**DOCKET****09-AFC-6**

**RE: BLYTHE SOLAR POWER PLANT (09-AFC-6), DATA REQUESTS  
SET 1 (#1-260)**

This set of data requests (#1-260) is being made in the areas of Air Quality (#'s 1-29), Alternatives (#'s 30-44), Biological Resources (#'s 45-97), Cultural Resources (# 98-152), Efficiency (# 153), Geological Hazards (# 154-156), Public Health (# 157-164), Reliability (# 165), Soil & Water Resources (# 166-229), Transmission System Engineering (# 230-231), Visual Resources (# 232-252), Waste Management (# 253-258) and Worker Safety and Fire Protection (# 259-260). Written responses to the enclosed data requests are due to the Energy Commission staff on or before January 6, 2010 or at such later date as may be mutually agreeable.

**DATA REQUEST - FIGURE 1**  
 Blythe Solar Power Project - Alternative Site

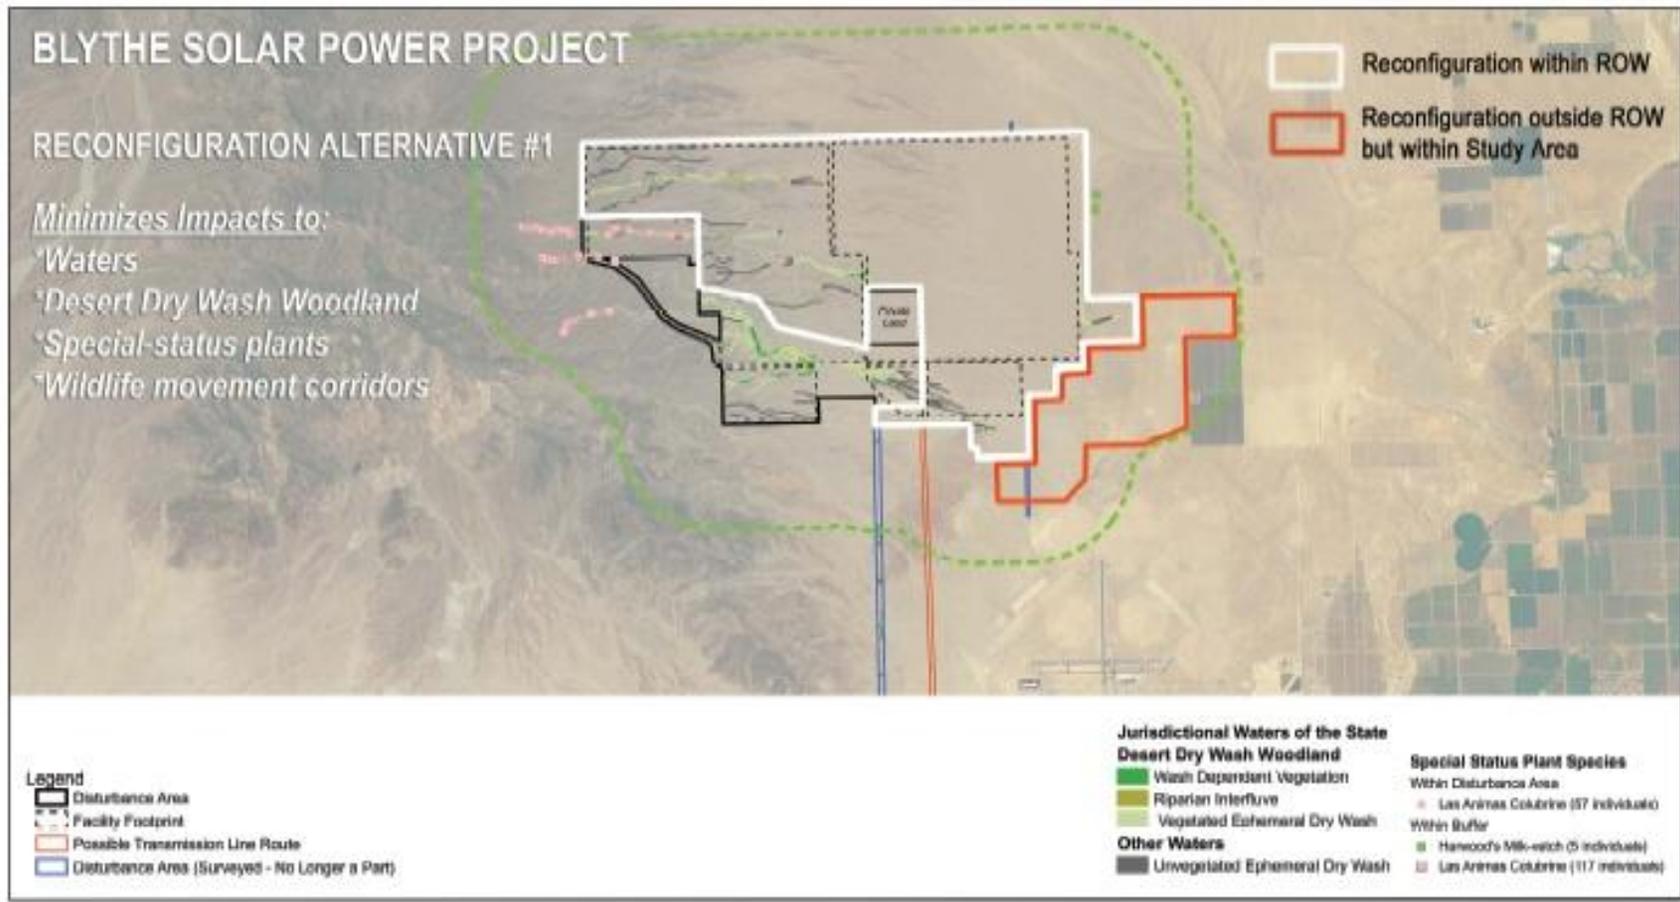
In order to define alternative sites that would be potentially viable, Staff has reviewed scoping comments (for the PEIS for solar development on BLM-administered land) and met with Energy Commission and BLM staff and identified other potentially viable sites. We have identified a potential additional site called the Blythe Disturbed Land alternative. In order to further evaluate this site, additional information is required. A GIS file of the Blythe Disturbed Land alternative will be provided along with this data request. A map in PDF format is attached (see Data Request Figure 1.)

38. Please provide the results of a CNDDDB search for the Blythe Disturbed Land alternative site.
39. Please provide an Information Center search (Class I) for recorded sites identified within the Blythe Disturbed Land alternative site.

**Alternatives Data Request Figure 2. Reconfigured Alternative**

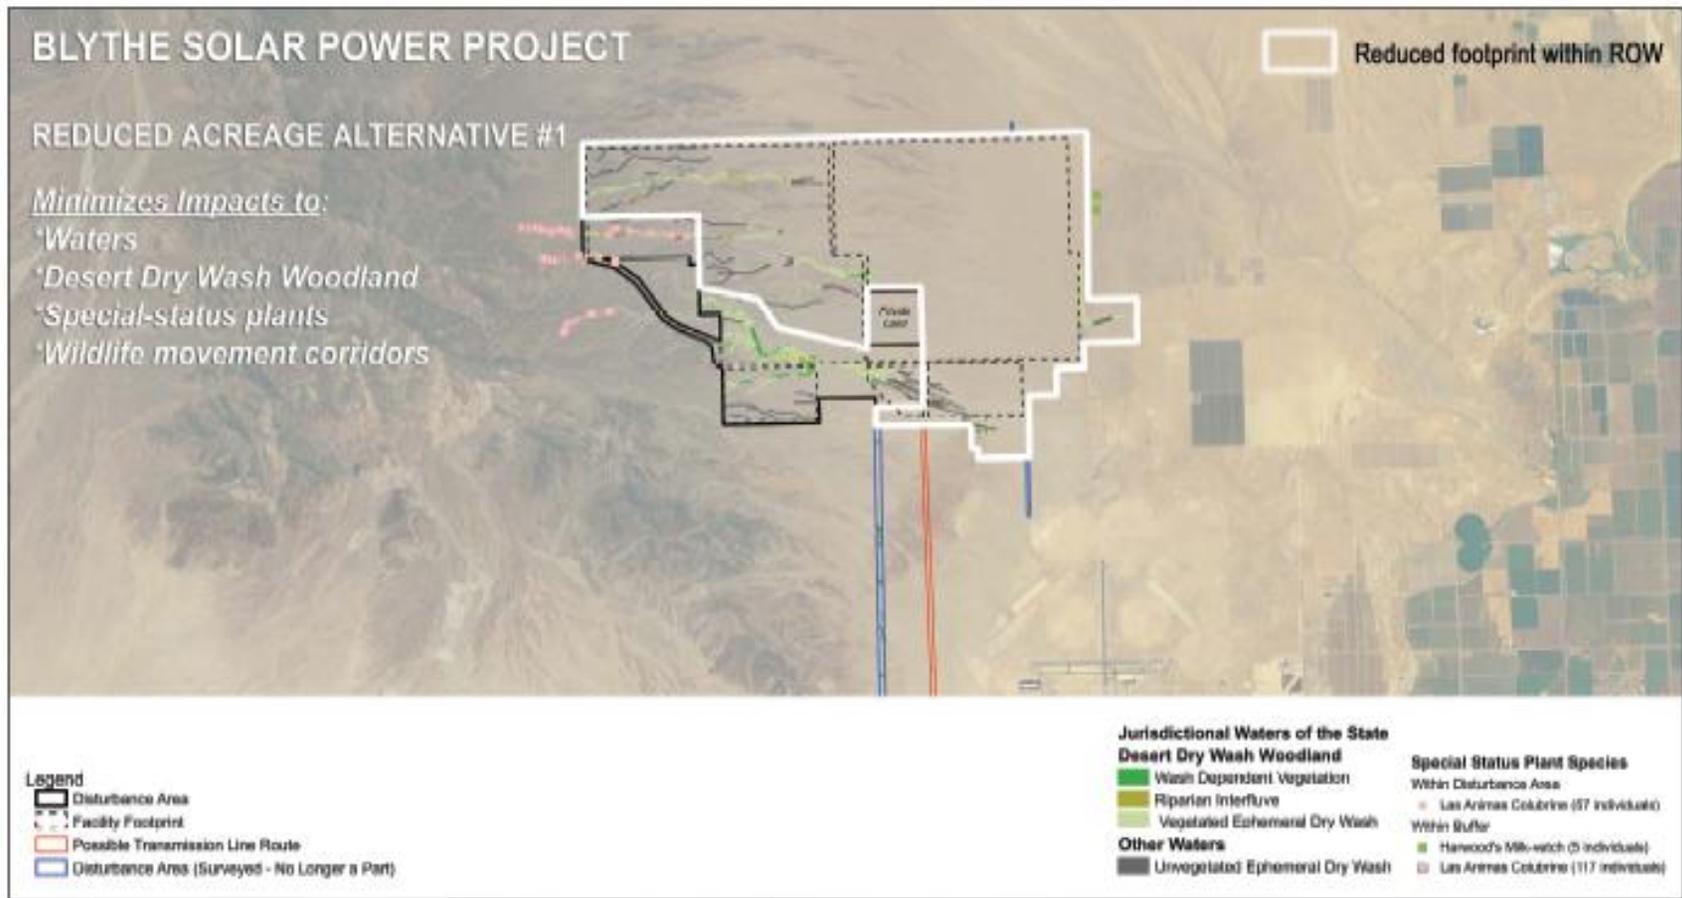
43. Please see **Alternatives Data Request-Figure 2**, which illustrates areas within the project boundaries that are occupied by the most sensitive biological resources -- desert washes (shown in green) and special status plant species (shown in pink). The areas outlined in red identify potential revised configurations that would reduce effects on these resources. In order for the Energy Commission and BLM to evaluate a potential alternative that avoids effects on
